REFERENCE LHC-TC-EC-0014

Date: 2018-06-25

ENGINEERING CHANGE REQUEST

First Phase of Installation of Low Impedance Secondary Collimators (TCSPM) in IR7

Figure 1 — 3D view [5] of the TCSPM collimator (SmarTeam code: ST0948103), showing an extremity of the jaw with the embedded BPM, the “third” BPM for orbit measurements in the plane orthogonal to the collimation plane, and the new tapered transitions made of MoGr.

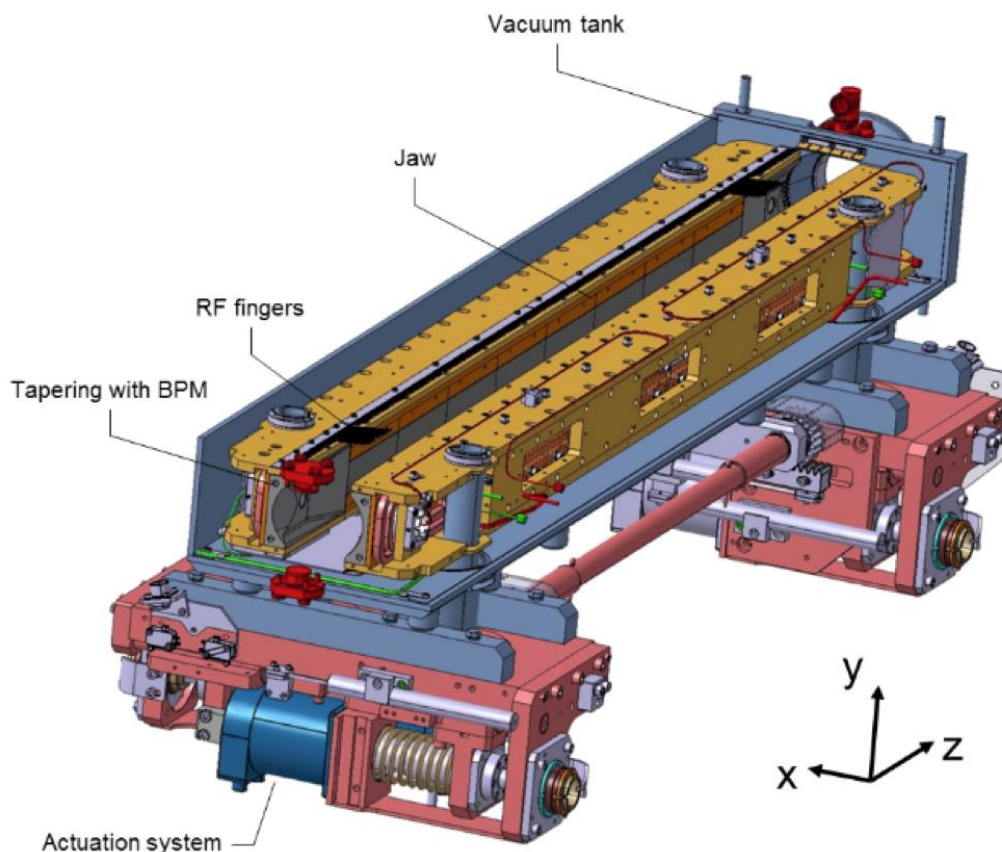
The present TCSPM design [5] (see

Figure 1) is an evolution of the present TCSGs [1]; among the most noticeable differences, there are material and coating of the jaw, and the presence of in-jaw Beam Position Monitors (BPMs). Other features are described in [6].

The design foresees jaws made of a composite material (MoGr) obtained from Molybdenum and graphite, chosen for its similar robustness and superior impedance characteristics with respect to the jaw material of the present TCSGs, in particular since a thin, 5 μm -thick coating layer will be deployed. The collimator jaws are equipped with BPM button pick-ups, for an easy determination of the beam closed orbit at the collimator and fast and precise alignment of the jaws. A third BPM is installed on the tank, to measure the beam position on the axis orthogonal to the one of cleaning. The BPMs shall be added in the database with the same notations used for the present TCTP and TCSP collimators. Table 1 summarises the main collimator parameters of the TCSPM design, whereas Table 2 - SmarTeam codes of the assembly sub-modules. lists all the SmarTeam codes of the assembly submodules.
